425 Forest

**Helen Donaldson - Re: 425 Fore**

**From:** Helen Donaldson  
**To:** anthony muench  
**Date:** 3/17/2015 4:24 PM  
**Subject:** Re: 425 Fore  
**Attachments:** Re Fore Street Plaza Project.pdf

**Recessed wall luminaires with shielded light source**

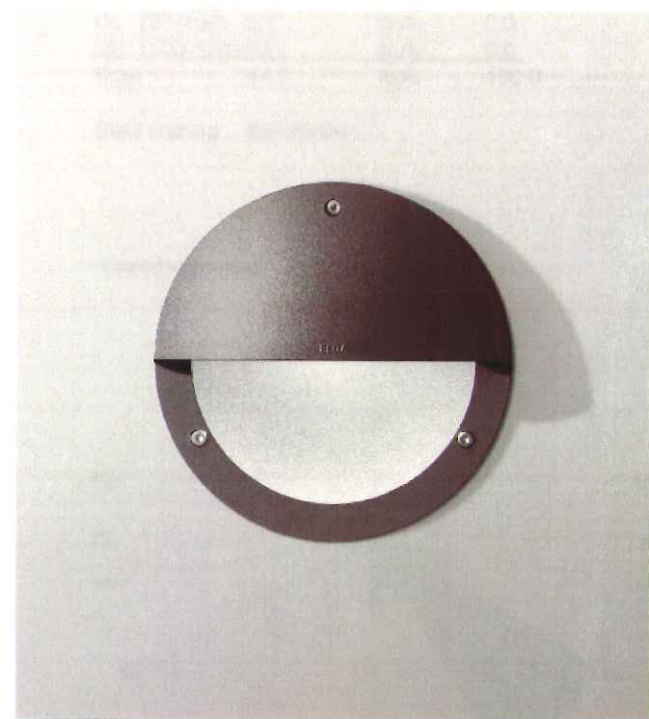
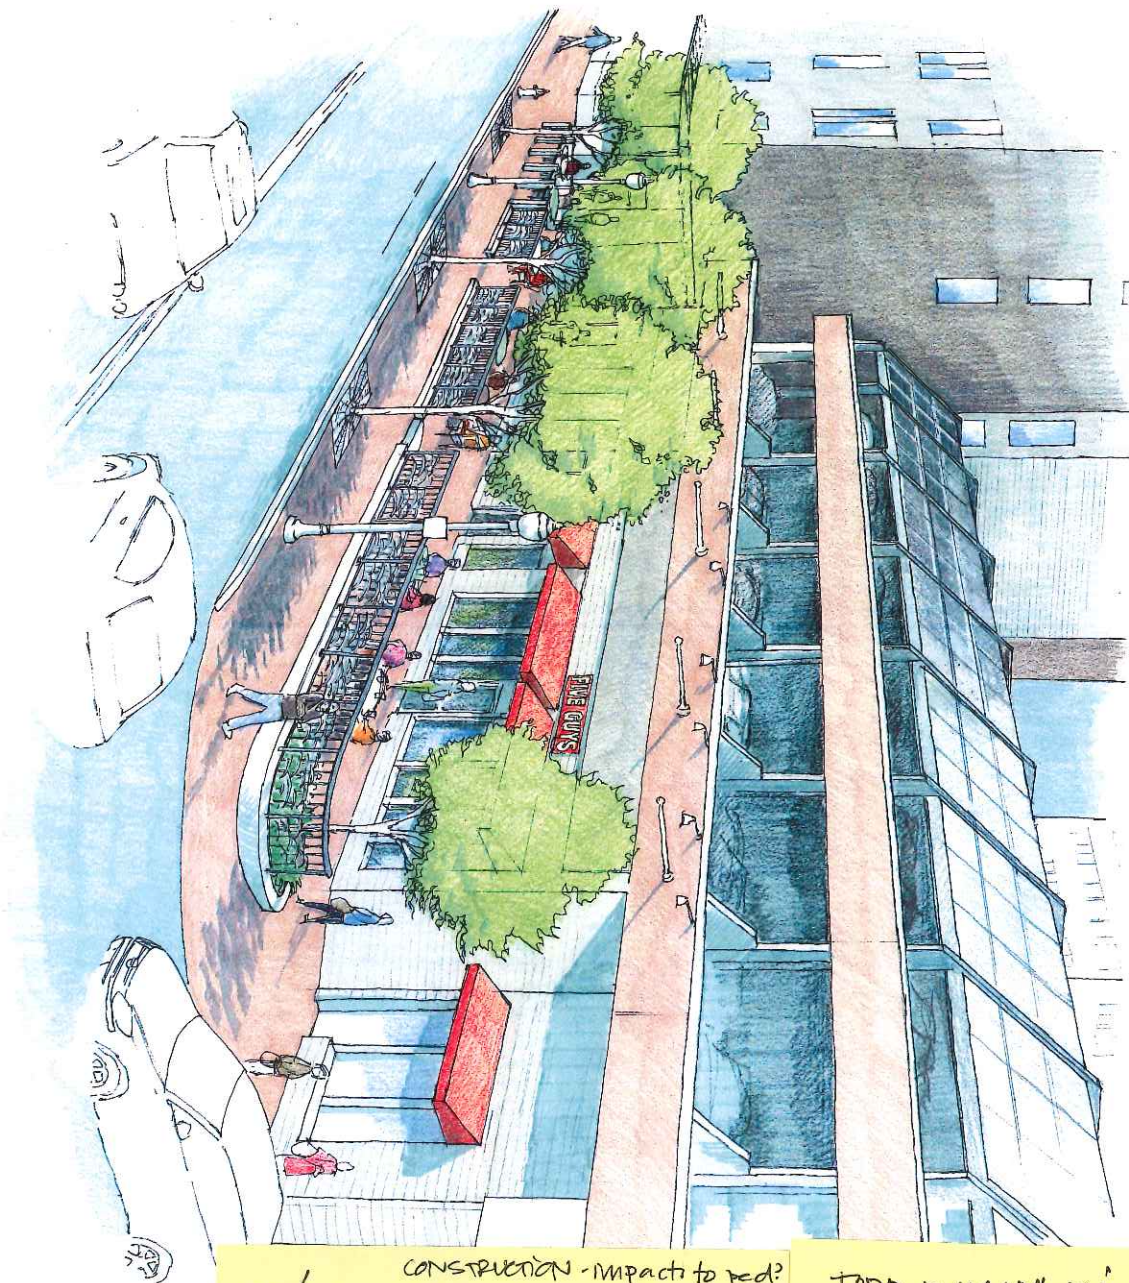
*lights ok per  
Dubs 9/14/15*

Regarding the bollard lights, I apologize that in my previous email I was mistakenly recalling a conversation about bollard lighting specs in the city's ROW. Obviously, these bollards are not in the ROW, so you should be fine. However, the lights do need to conform with the city's technical manual. I looked into the spec but couldn't find a cut sheet online. Could you provide one?

If bollards are to be used, I need a little more detail on the lighting. Just so you know, this may be a tough sell.
